ORIGINATION FORM

Proposed Revisions to a Standard Plans Index
(Please provide all information — Incomplete forms will be returned)

Index Number: 102-660
Sheet Number (s): 2 of 2
Index Title: Sidewalk Closure

CHANGED TO: PEDESTRIAN DIVERSION

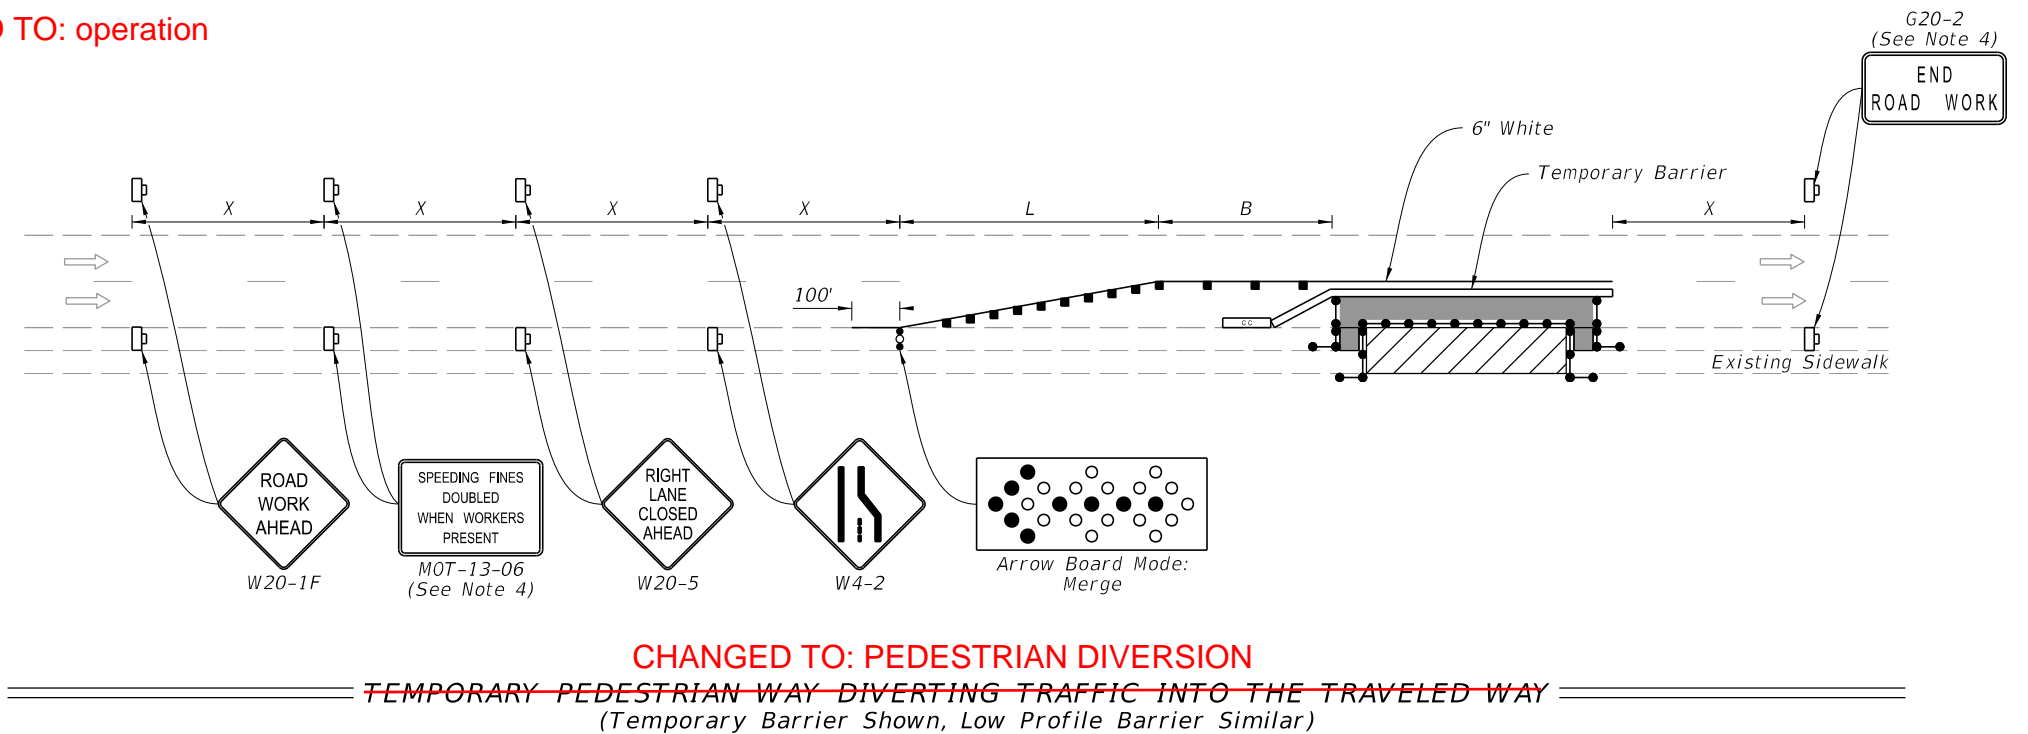
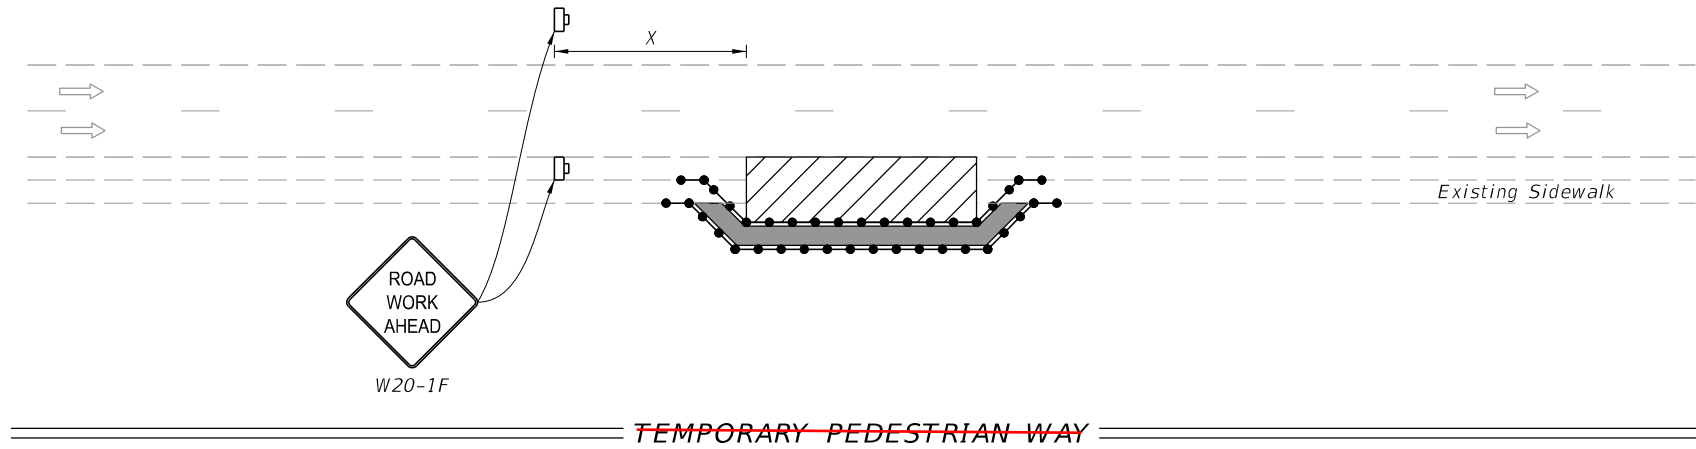
ADDED NEW DETAIL:

CHANGED TO: PEDESTRIAN DIVERSION (Work Zone Speed 35 mph or Less)

5. **CHANGED TO: operation**

ADDED NOTE 5:
Pedestrian Diversion may only be used when called for in the Plans or as approved by an Engineer.

~~TEMPORARY PEDESTRIAN WAY DIVERTING TRAFFIC INTO THE TRAVELED WAY~~
(Temporary Barrier Shown, Low Profile Barrier Similar)

Sheet 2: Changed Note 4 - "work zone" to "work operations"; Added Note 5 - "Pedestrian Diversion may only be used when called for in the Plans or as approved by an Engineer."; Changed title "TEMPORARY PEDESTRIAN WAY" to "PEDESTRIAN SPECIAL DETOUR"; Changed title "TEMPORARY PEDESTRIAN WAY DIVERTING TRAFFIC INTO THE TRAVELED WAY" to "PEDESTRIAN DIRVERSION"; Added new detail "PEDESTRIAN DIRVERSION (Work Zone Speed 35 mph or Less).

The duration provisions of the index are intended to apply to the length time needed to perform the specific temporary traffic control work "operation" shown, which is independent of the duration of an overall construction project. The term "Work Zone" is being replaced with "Work Operation" to clarify the intent.

PEDESTRIAN DIVERSION - OPTION 2
(Work Zone Speed 35 mph or Less)

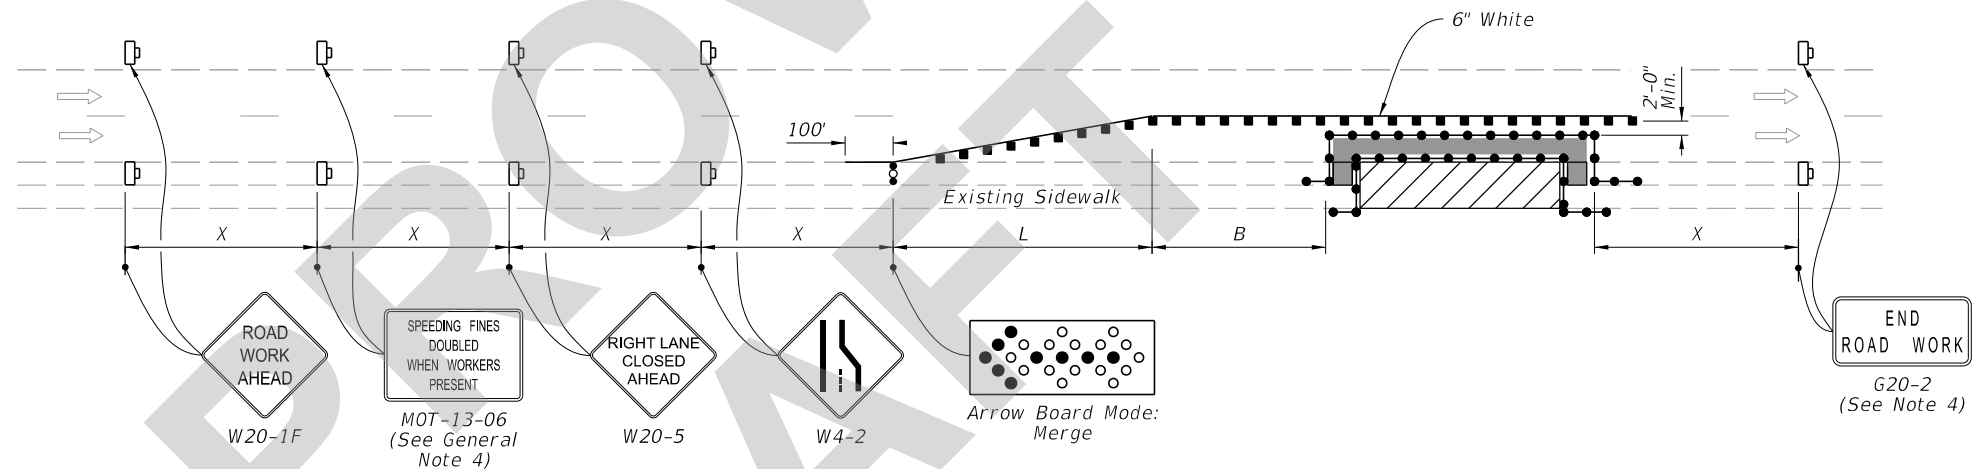
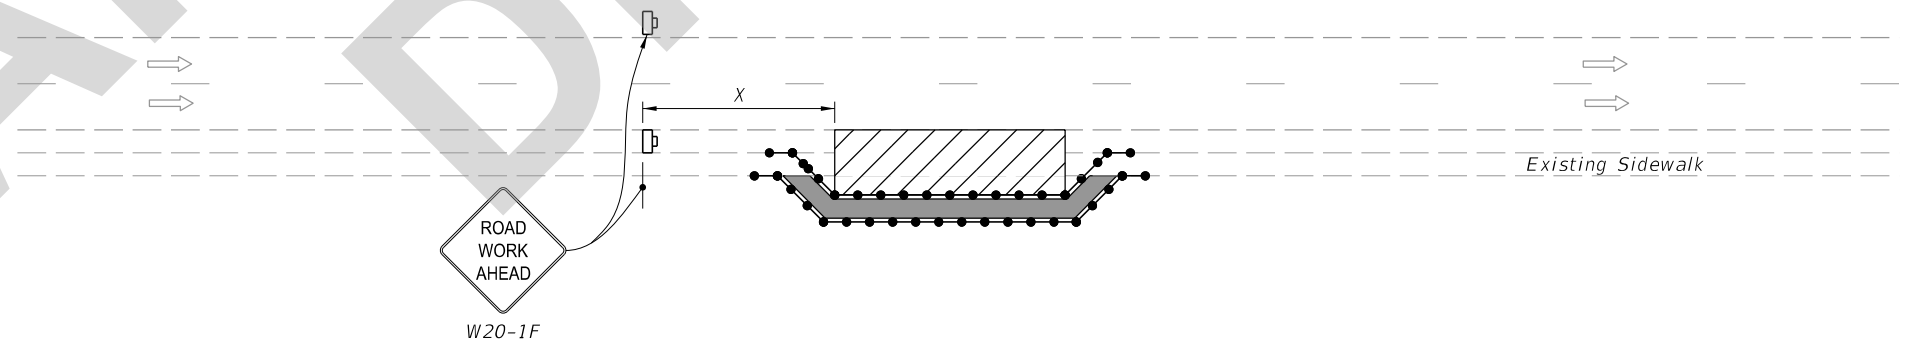
4. The "Speeding Fines Doubled When Workers Present" signs (MOT-13-06) and "End Road Work" signs (G20-2), along with associated work zone sign distances, may be omitted when the work operation will be in place for 24 hours or less.

5. Pedestrian Diversion Option 2 may only be used when called for in the Plans or as approved by an Engineer.
